# Access Compliance Report

## Public Rights-of-Way

### (Pedestrian Signals)

Intersection ID: N/A	Main Street:	Cross Street: N/A	Location: N/A
ADA ID: 81F83884C7DA	Signal Type: Two Push Buttons-Non APS	Overall Compliance: No	Severity Score: BTN 1:N/A BTN 2: N/A No BTN: N/A
Codes/Mitigation Info/Possible Solution		Field Measurements/Component Compliance

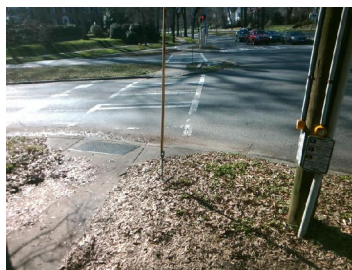
Yes	B 1 Clear Xing Direction?	ClearlyMarked	Yes	B 2 Clear Xing Direction?	ClearlyMarked
	B 1 Crossing Direction	To NW		B 2 Crossing Direction	To S
Yes	B 1 DistanceTo XWalk (in)	0.0	Yes	B 2 DistanceTo XWalk (in)	58.0
No	B 1 DistanceTo Curb (in)	118.0	Yes	B 2 DistanceTo Curb (in)	60.0
Yes	B 1 Diameter (in)	2.0	Yes	B 2 Diameter (in)	2.0

Possible Solutions: Replace Signal Push Button With APS Button on New Post. Remove & Relocate Sign. Provide PAR As Indicated. Provide Clear Space.
